Access Compliance Report

Public Rights-of-Way

(Curb Ramps)

Intersection ID: 10004304	Main Street: MULLAN_LN	Cross Street: REALTA_DR	Location: SE
ADA ID: C1620E675A1E	Ramp Type: Perp	Initial Pass/Fail: Fail	Overall Compliance: No
Severity Score: 8.75			
Codes/Mitigation Info/Possible Solution		Field Measurements/Component Compliance

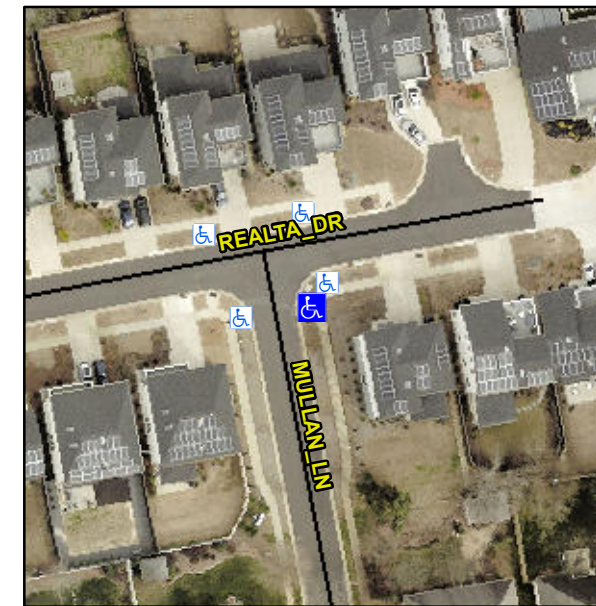
Possible Solutions:

Remove & Replace Entire Ramp.

PROW/ADA:

R304.5.1

Compliance	Description	Data	Compliance	Description	Data
N/A	Ramp Length (in)	95.0	Yes	Ramp Slope (%)	7.2
No	Ramp Width (in)	47.5	Yes	Ramp XSlope (%)	1.8
N/A	Flare Type LT	N/A	N/A	Flare Type RT	N/A
N/A	Flare Slope LT (%)	N/A	N/A	Flare Slope RT (%)	N/A
N/A	Flare Traversable LT?	N/A	N/A	Flare Traversable RT?	N/A
N/A	Landing Length (in)	N/A	N/A	DWS Provided?	N/A
N/A	Landing Width (in)	N/A	N/A	DWS Contrast?	N/A
N/A	Landing Slope (%)	N/A	N/A	DWS Length (in)	N/A
N/A	Landing X Slope (%)	N/A	N/A	DWS Full Width?	N/A
N/A	Landing Curb? (Y/N)	N/A	N/A	DWS Offset (in)	N/A
N/A	Shared Landing?	N/A			
N/A	Gutter Ponding?	N/A	N/A	Gutter Slope (%)	N/A
N/A	Gutter Lip Ht (in)	N/A	N/A	Gutter X Slope (%)	N/A
N/A	Painted X Walk1?	No	N/A	Painted X Walk2?	N/A
	X Walk 1 Direction	To W		X Walk 2 Direction	N/A
N/A	X Walk 1 Width (in)	N/A	N/A	X Walk 2 Width (in)	N/A
	X Walk 1 Slope (%)	1.3		X Walk 2 Slope (%)	N/A
	X Walk 1 X Slope (%)	0.8		X Walk 2 X Slope (%)	N/A
